PRODUCT/PROCESS CHANGE NOTICE (PCN)

PCN #: **TB1503-01** DATE: **July 22, 2015**
Product Affected: **TSSOP-20, TSSOP-24, TSSOP-28,
TSSOP-48, TSSOP-56, TVSOP-48
SOIC-28, SSOP-20, SSOP-28,**
(Refer to Attachment II for affected part# shipped in Reel)
Date Effective: **November 2, 2015 Earliest Date - Refer to
specific date by package type**

This notification is to advise our customers that IDT has planned to standardize the carrier tape used to one type on selective package types.

Illustration of Carrier Tape Pocket Design Change

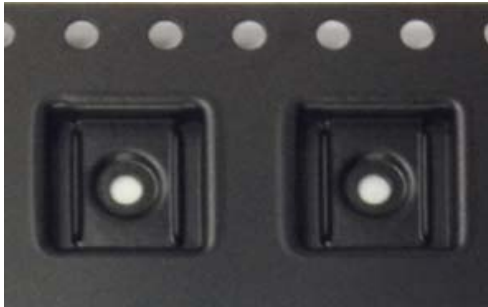
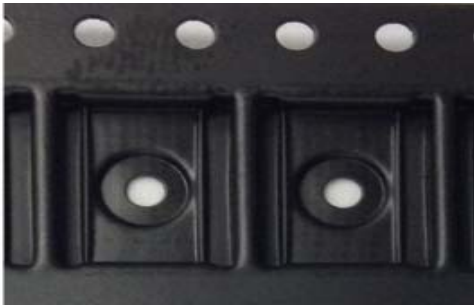
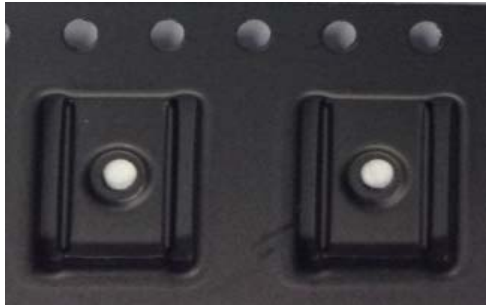
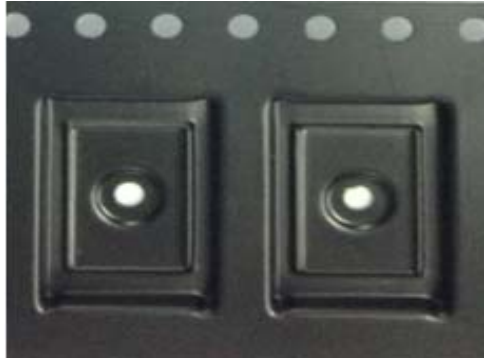
Package	From	To
TSSOP-20	Carrier Tape Part# P8-464-000 	Carrier Tape Part# P8-291-P20 
TSSOP-24	Carrier Tape Part# P8-329-P24 	Carrier Tape Part# P8-169-P24 
TSSOP-48	Carrier Tape Part# P8-260-P48 	Carrier Tape Part# P8-324-P48

Illustration of Carrier Tape Pocket Design Change

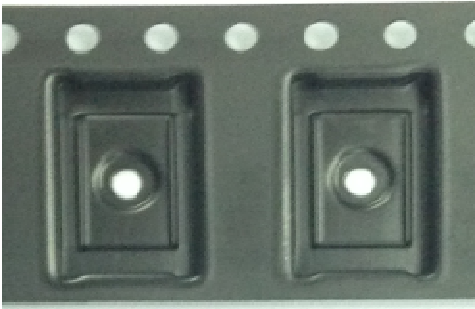
Package	From	To
SOIC-28	Carrier Tape Part# P8-187-S28 	Carrier Tape Part# P8-370-P28 
TSSOP-28 and TVSOP-48	Carrier Tape Part# P8-145-PF8 	Carrier Tape Part# P8-330-P48 
TSSOP-56	Carrier Tape Part# P8-261-P56 	Carrier Tape Part# P8-314-P56

Illustration of Carrier Tape Pocket Design Change

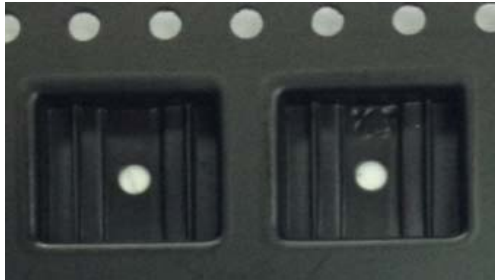
Package	From	To
SSOP-20	Carrier Tape Part# P8-259-P20 	Carrier Tape Part# P8-320-P20 
SSOP-28	Carrier Tape Part# P8-384-P28 	Carrier Tape Part# P8-321-P28
